Advisory notice

We apply in writing to you as an owner of our 3-wheeled Cheetah.

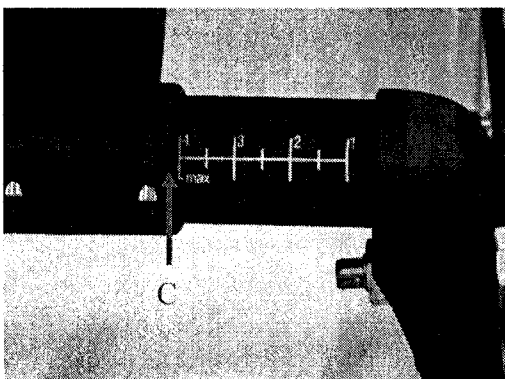
Since we have experienced a possible horizontal movement (A) of the wheel suspension (B), we would like to draw the attention to this area.

The movement can over time result in a placing of the wheel suspension which was not intended. If the movement exceeds to the most outlying adjustment (C) the wheel suspension exceeds the optimal adjustment.

Since this movement is not intended, we wish to prevent this movement by improving the design.

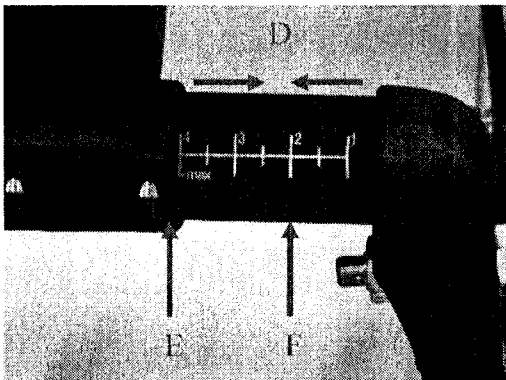
When using your present product until receiving the new replacement product, we would like to draw your attention to the following two precautions:

The wheel suspension (B) must NOT exceed the most outlying adjustment (C).

An exceeding of the most outlying adjustment is most likely to occur on the Cheetah size 3 and 4. If you have a size 3 or a size 4 you must be extra attentive.

You can control a possible movement (A) by measuring the distance (D) every day or by comparing the distance between the edge (E) and the measuring scale (F) every day.
